REVISION NO. 6 **JUNE 24, 2016**

THE MEDICAL CENTER OF AURORA RENOVATIONS
Aurora, Colorado

ESa PROJECT NO. 14077.00

These revisions form a part of the Contract Documents and modify the original CONSTRUCTION DOCUMENTS, dated December 30, 2014, as outlined here in addition to being shown on the drawings as Delta No. 6, dated June 24, 2016.

M1.03.1

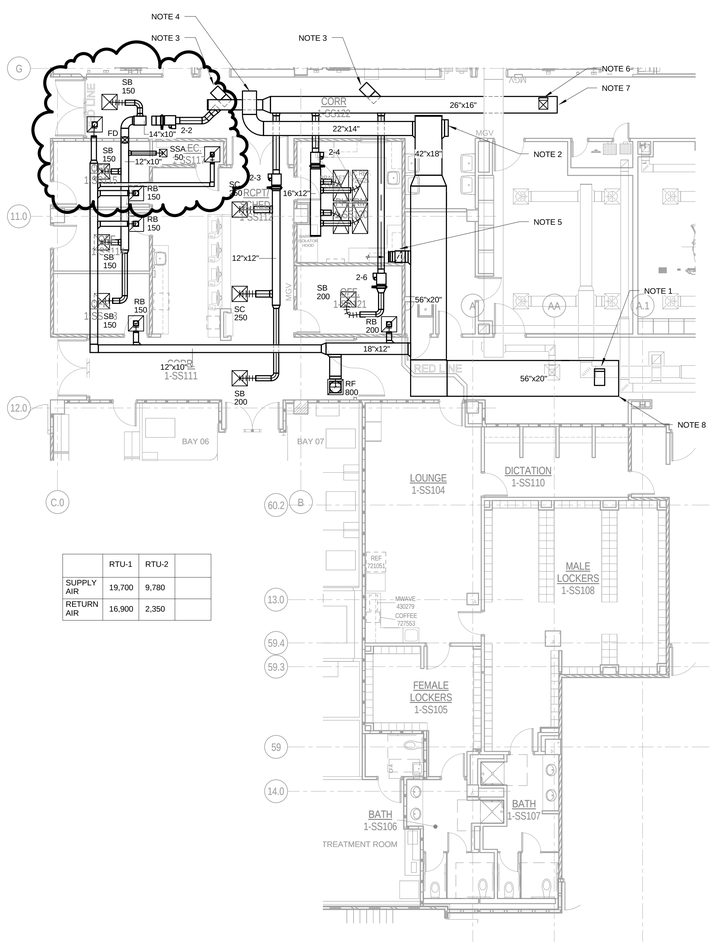
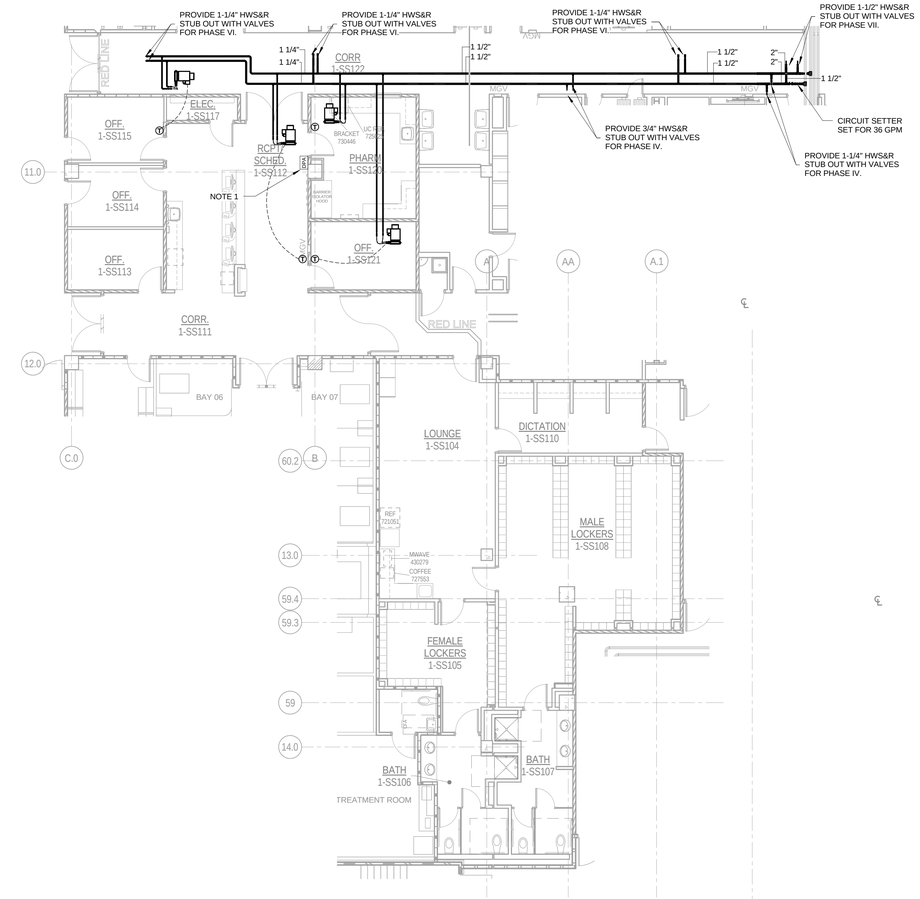
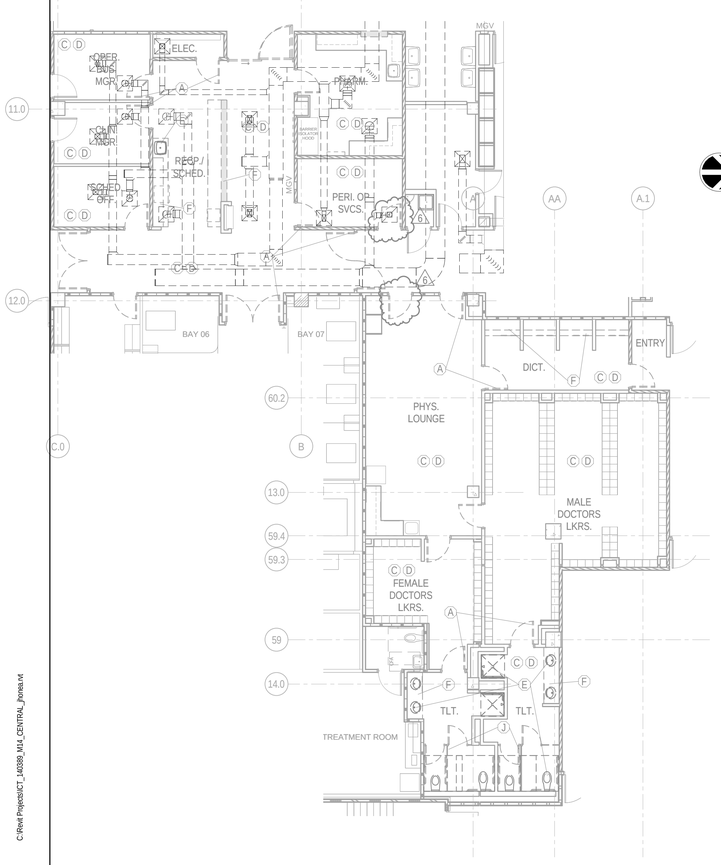
1. Revised duct layout to match architectural background changes.

M1.06

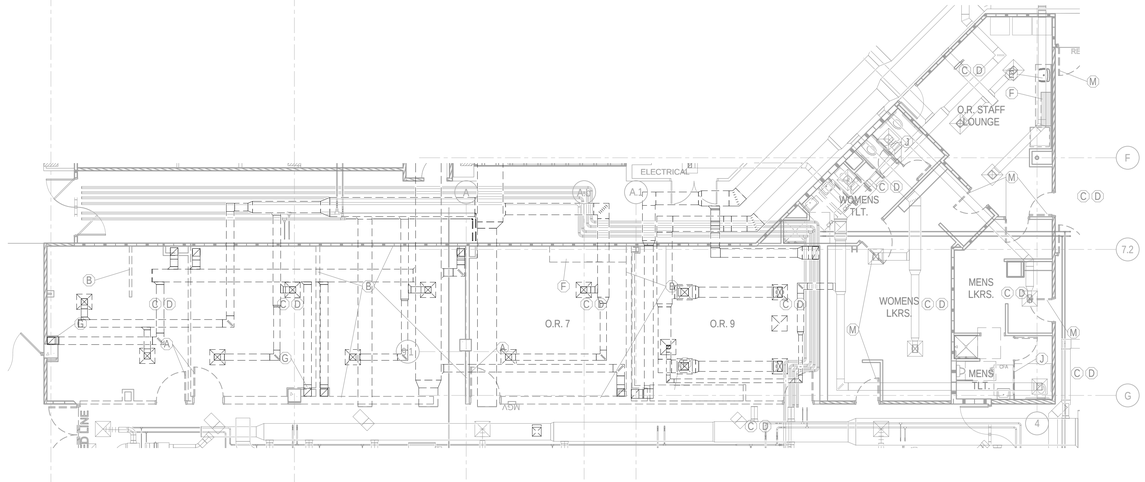
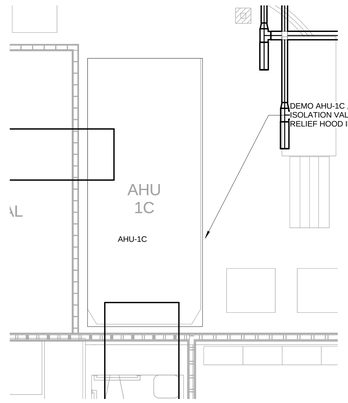
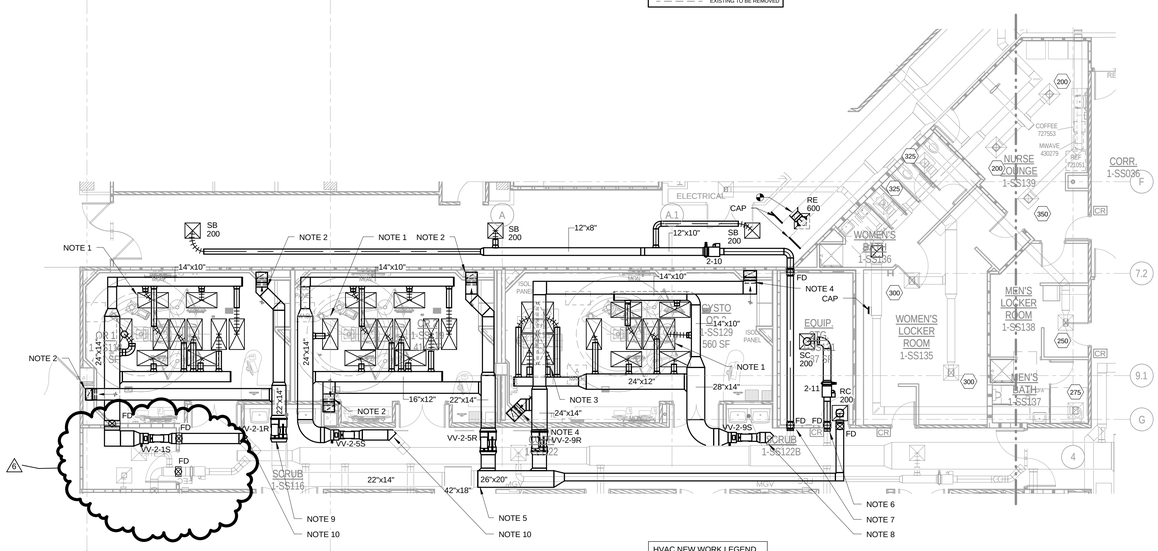
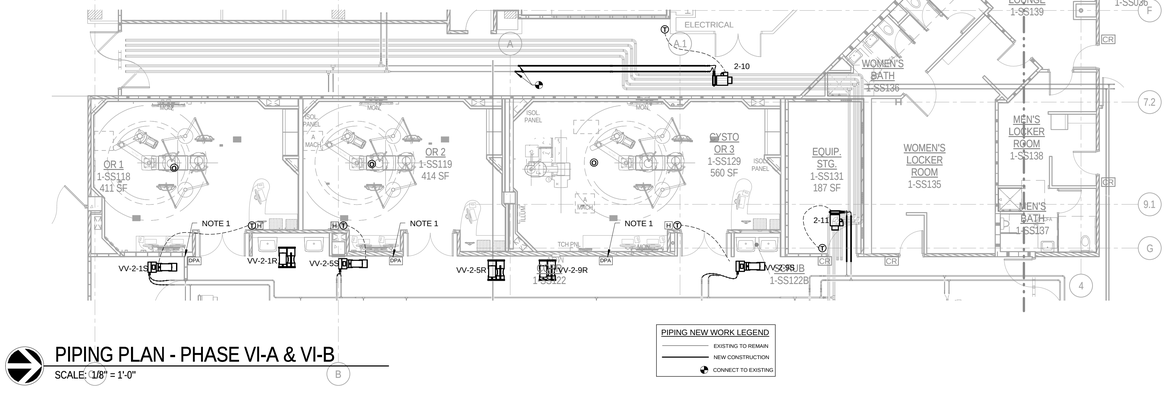
1. Revised duct layout to match architectural background changes.

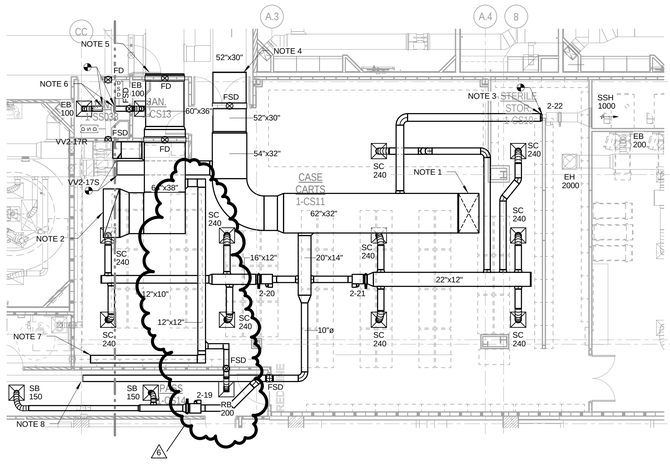
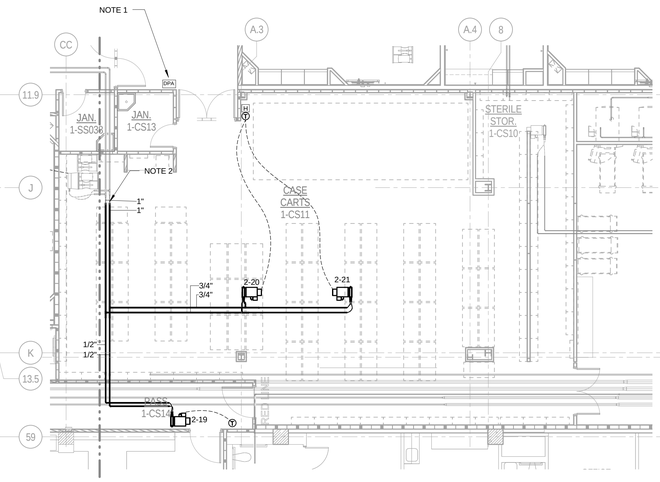
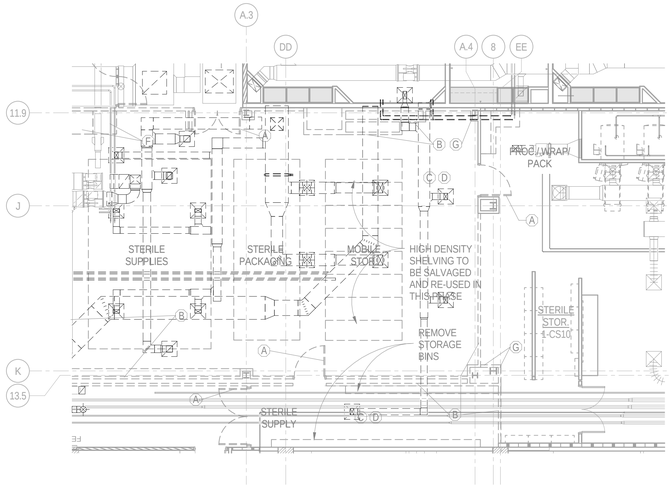
1. Added return diffuser to corridor.

P2.03

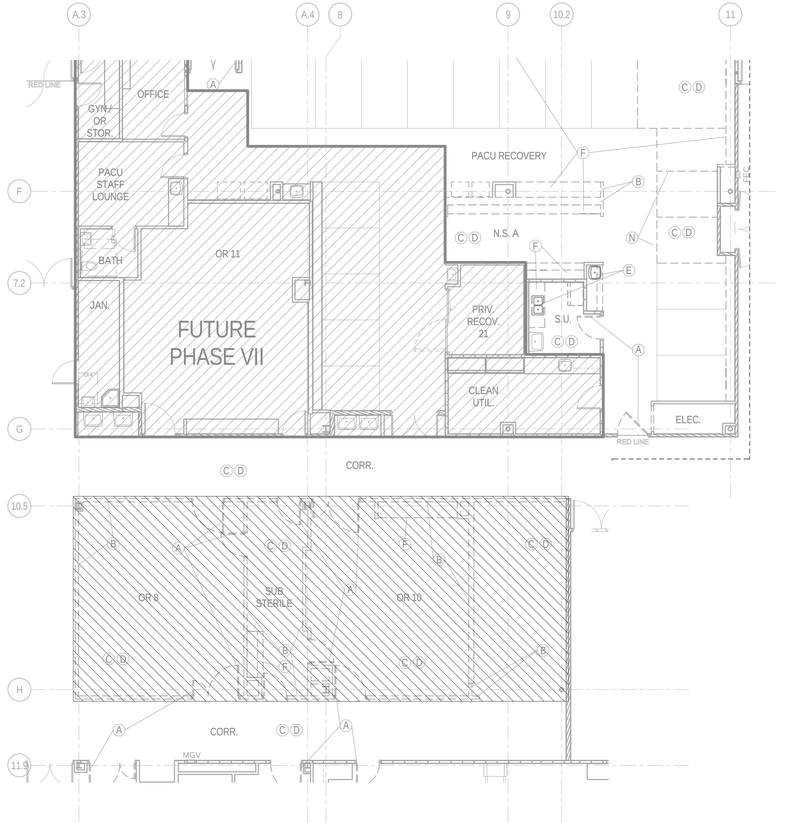
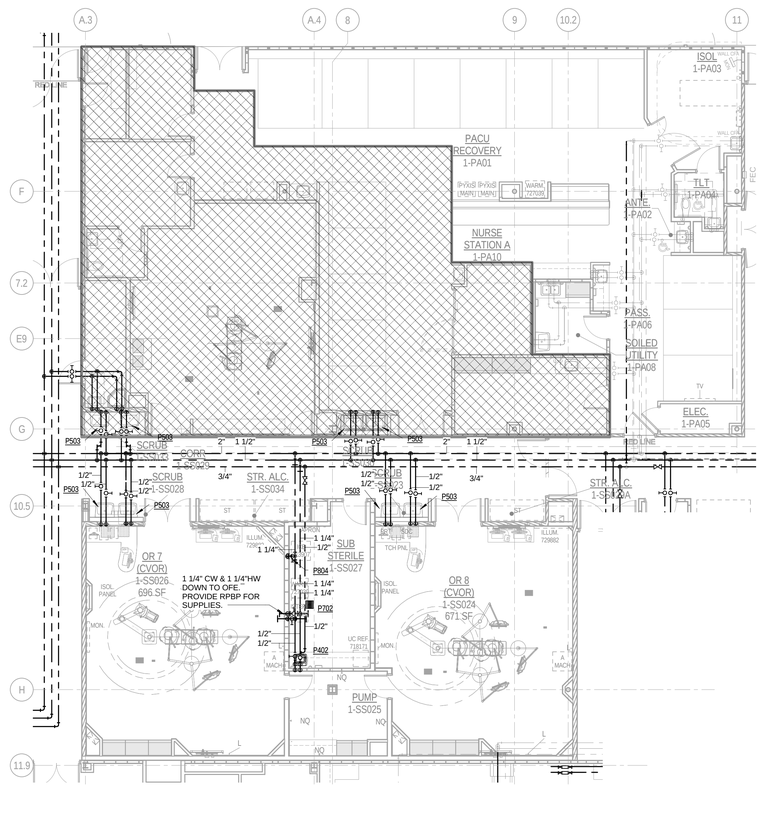
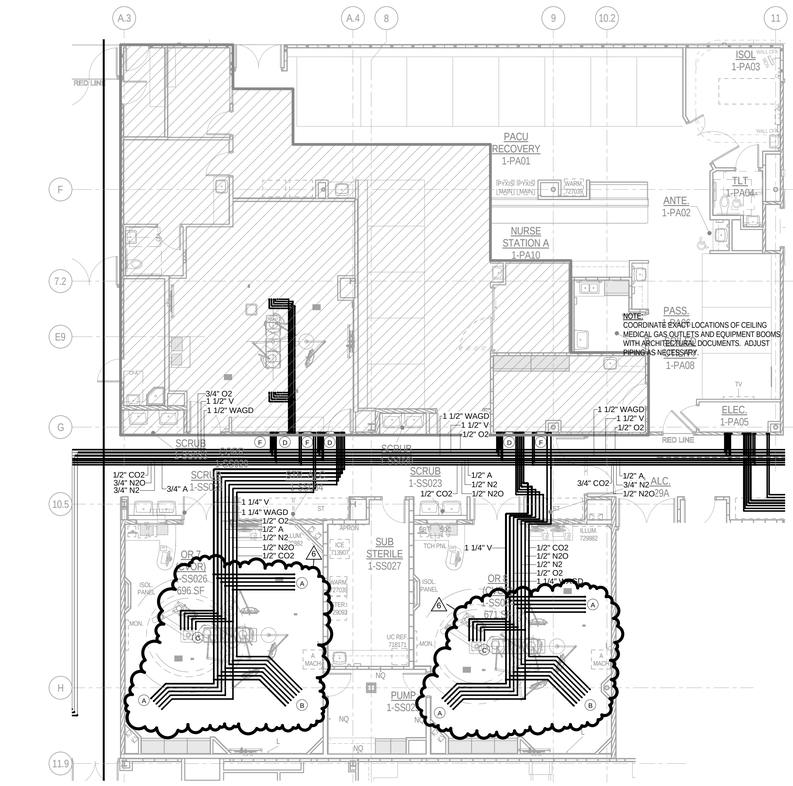
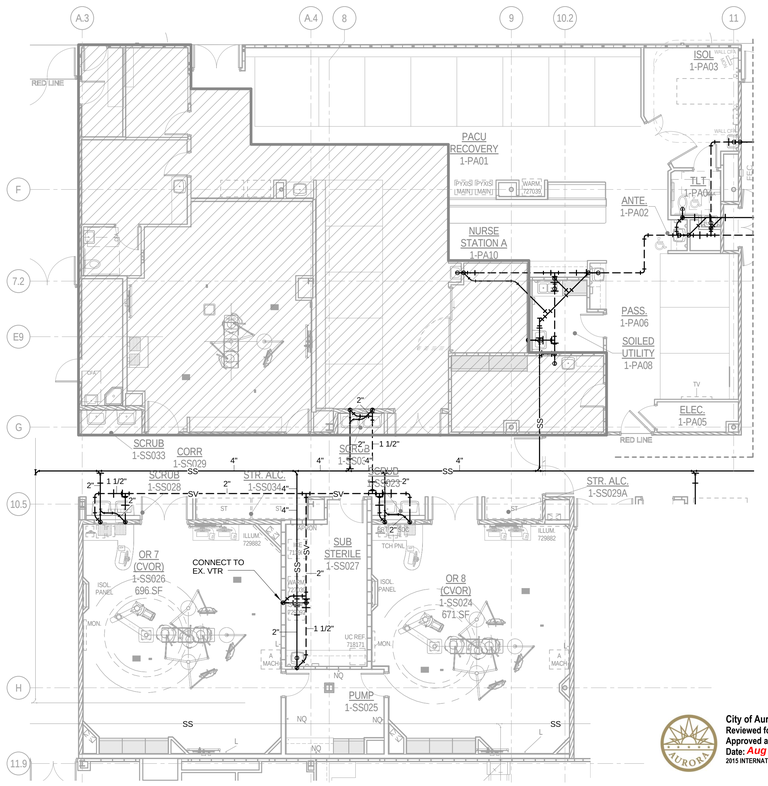
1. Revised medical gas locations to match architectural ceiling plan.

T1.03

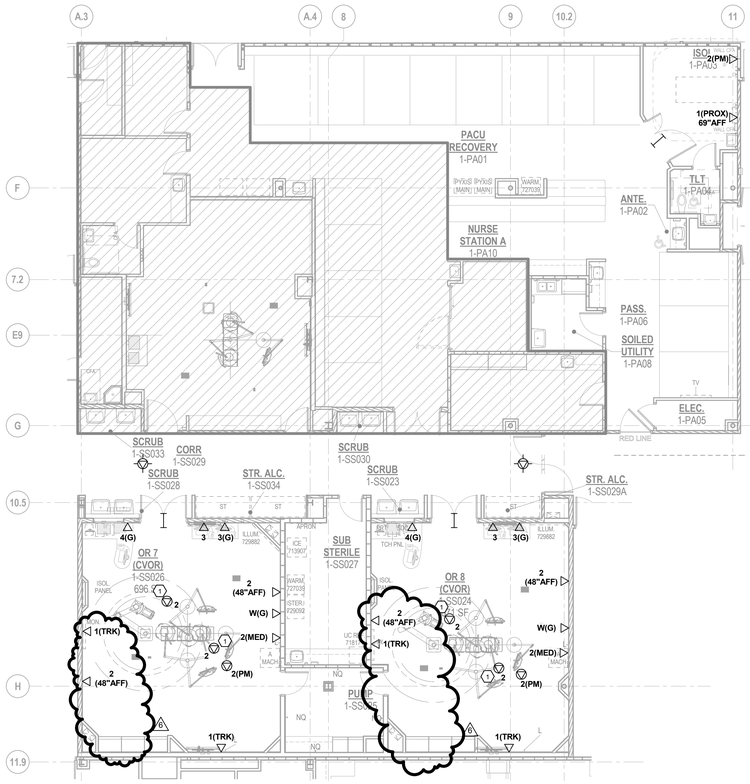
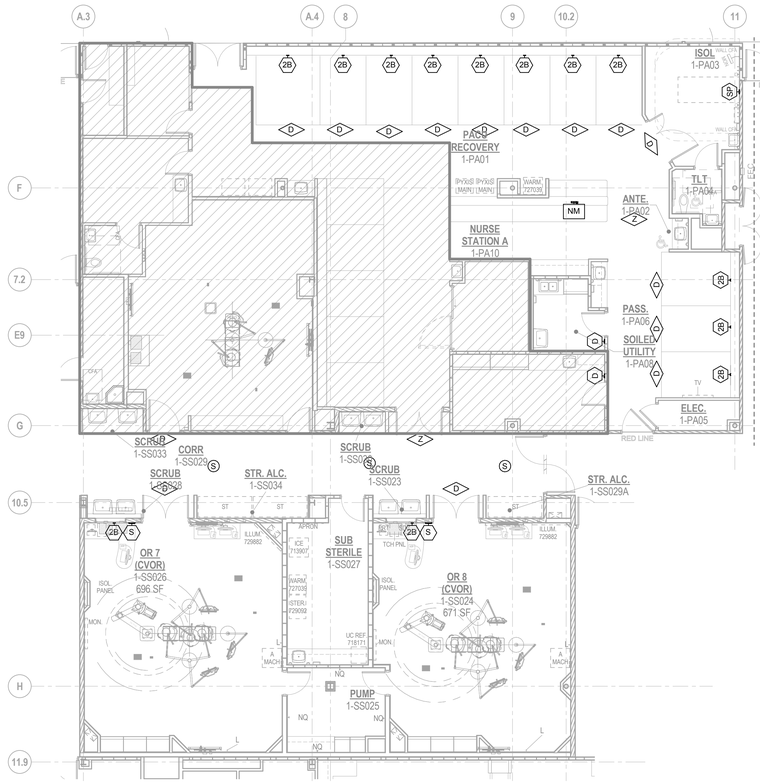
1. Revised telecommunications outlet locations to reflect architectural floor plan change.

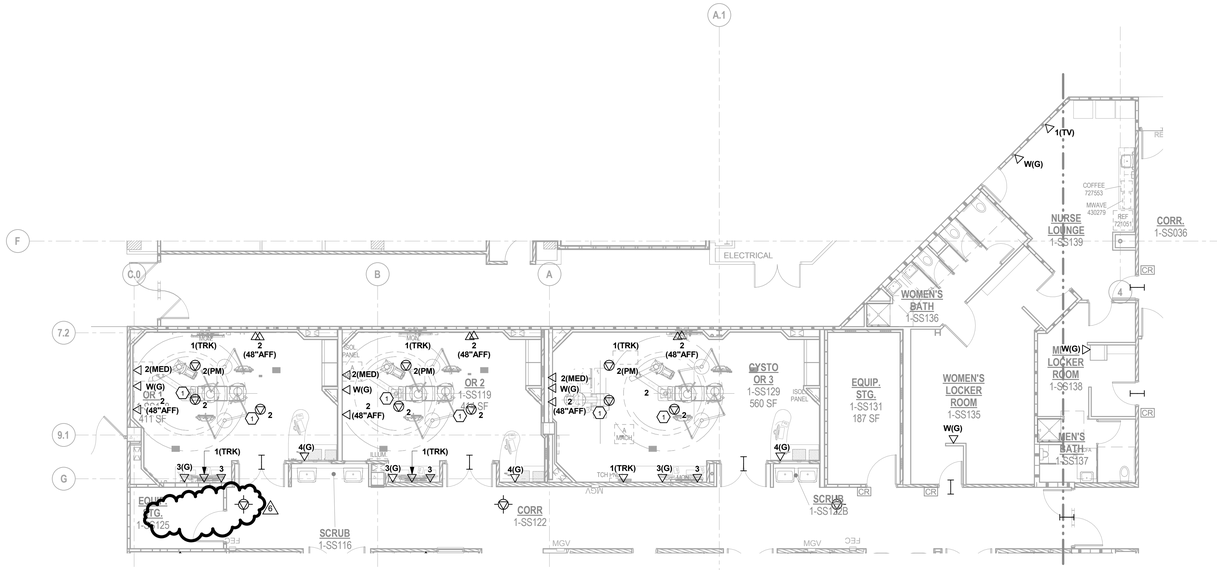
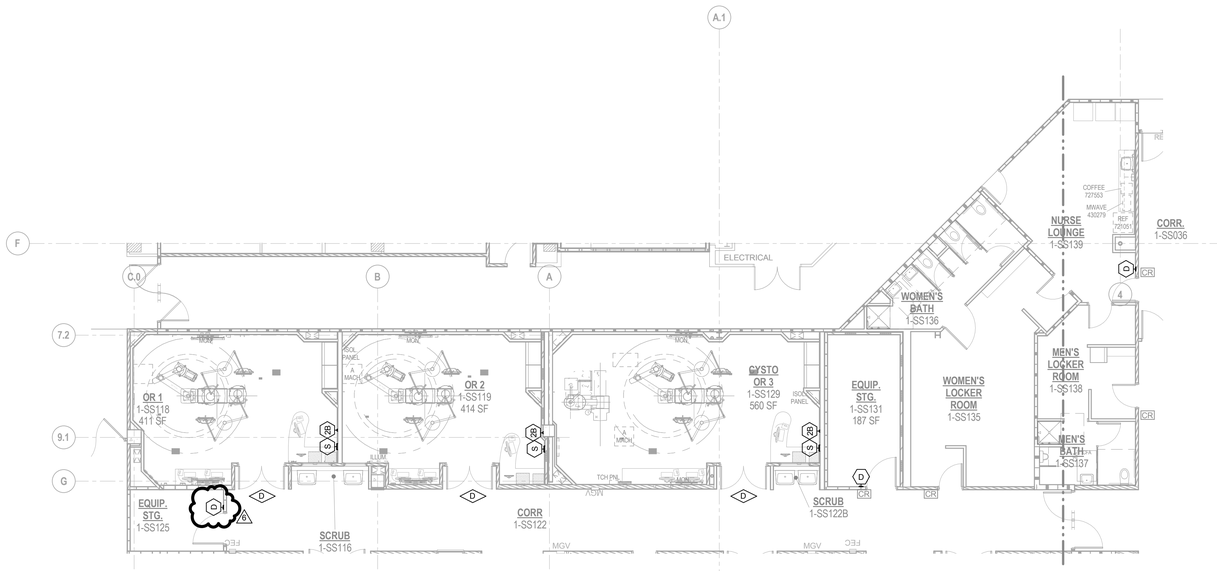
1. Revised telecommunications outlet locations to reflect architectural floor plan change.
2. Revised communications outlet locations to reflect architectural floor plan change
